ADDENDUM NO. 1

Project Number: R.100644.001

CSC-COW BARN & MANURE TANK (DOCUMENT SET 2) PUBLIC SERVICES AND PROCUREMENT CANADA ENTRY MAT LOCATION IN VESTIBULE C01		PROJ. #: THA:1945 R.100644.001	ADDENDUM 1 SK-02
TAYLOR HAZELL ARCHITECTS LTD. 2928 DUNDAS ST. W, TORONTO, ONT. M6P 1Y8	PHONE: (416) 862-2694	DATE: 2021-01-05	SCALE: 1:50 R1

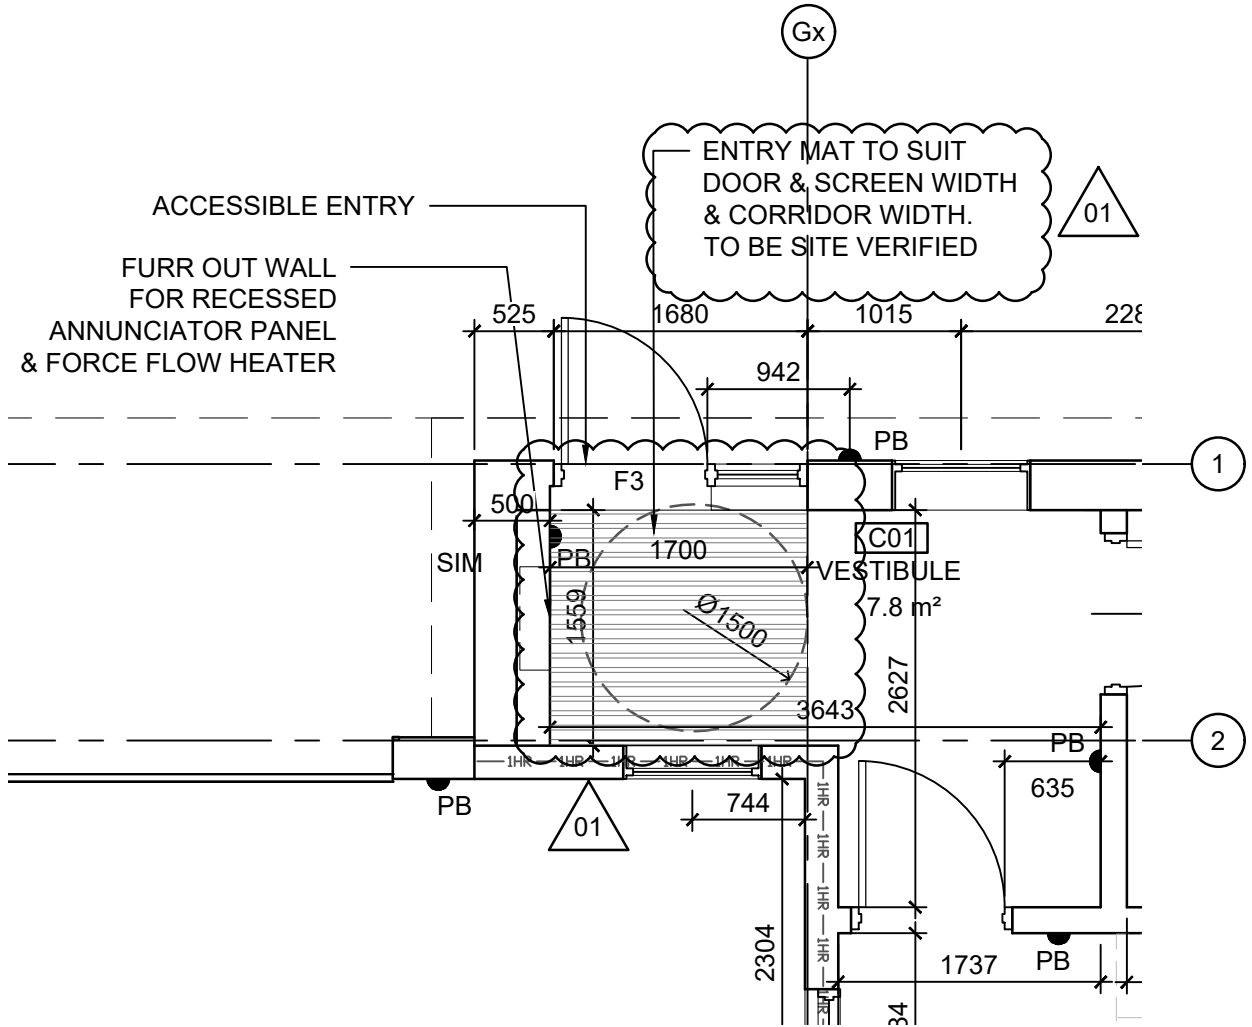
1. DRAWING A-9.0 MILLWORK DETAILS
 1. Remove Detail 7 for Staff washroom bench
2. DRAWING A-C-8.0 INTERIOR ELEVATIONS
 1. Replace millwork for bench base with integrated base to be supplied by locker manufacturer/ supplier. Refer to SK-01 Details 7,8 (interior elevations of staff washroom C04) & 30 (plan detail for staff washroom C04).
3. DRAWING A2.1 ENLARGED FLOOR PLAN/ EQUIPMENT LIST
 1. Add entry mat to suit dimensions of door and screen (+/-1700mm) x Corridor Width (+/- 1560mm) To be site verified. Refer to SK-02.
